Attachment 7

RE: CAMPBELL-SHEPPARD/DAN LLOYD E Street Project

RE: Cypress Glen Tentative Map (Tract 3074) Project; San Luis Obispo County, California
Evaluation of Project Trip Generation and Access

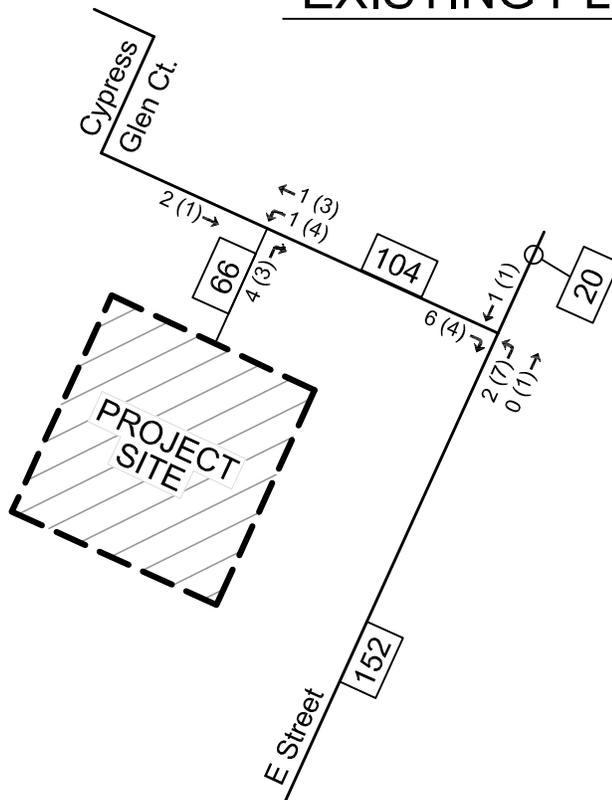
The existing and existing plus project traffic volumes are illustrated on Figure 1 (included with Attachment Material). The daily traffic volumes associated with the existing homes having access on E Street (5 SFDU near the project site) are also included on Figure 1. The volume data on Figure 1 demonstrates that development of the Cypress Glen TM Project will almost triple the amount of daily traffic on Cypress Glen Court west of E Street (2.74 times existing). Based on information provided by your office, it is my understanding that your client would prefer that access for the lots fronting E Street be provided via direct driveway connections to E Street. This would minimize the amount of new traffic generated on Cypress Glen Court and maintain the current level of safety for existing pedestrian and bicycle traffic.

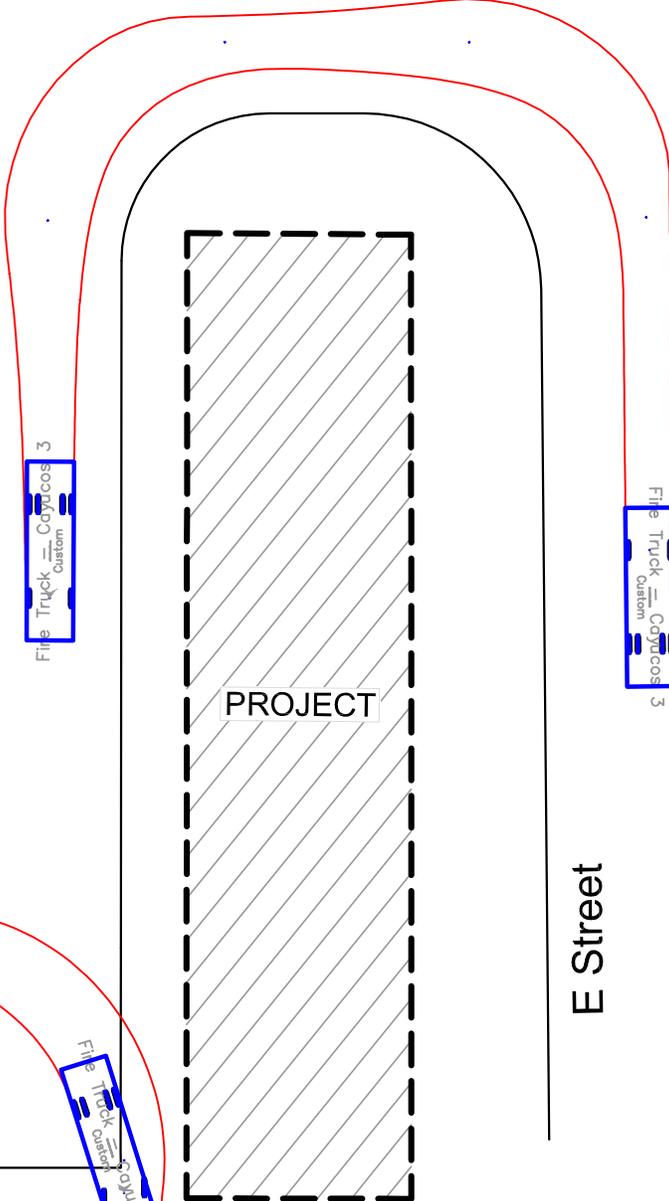
The evaluation of access includes a review of fire truck turning templates. Dimensions for local fire trucks were obtained from the Cayucos Fire Department. The department operates two (2) size trucks (23' and 29' long). The Cal Fire standards require that roadways be designed to facilitate the San Luis Obispo County Fire Department Fire Truck Design Template (copy included with the Attachment Material). The turning templates for the Cal Fire standard fire truck (length of 30'-4") were evaluated using the AutoCAD and AutoTURN software. The turning template maneuvers were performed for fire trucks accessing the project's private drive via E Street and Cypress Glen Court. At the southerly end of the project's private drive there is a designated "turnaround" area for emergency service vehicles. A turning template was also performed for a fire truck using the "turnaround" area. The fire truck turning templates are illustrated on Figure 2 (included with the Attachment Material).

The turning templates on Figure 2 demonstrate that a Cal Fire truck (design template) will be able to access the project's private driveway within the existing and proposed roadway widths. However, the designated "turnaround" area will not be adequate to accommodate the maneuvers associated with turning a fire truck around. Therefore, as previously stated it is unclear if the Cypress Glen TM Project will comply with all Cal Fire Standards. It also should be noted that the
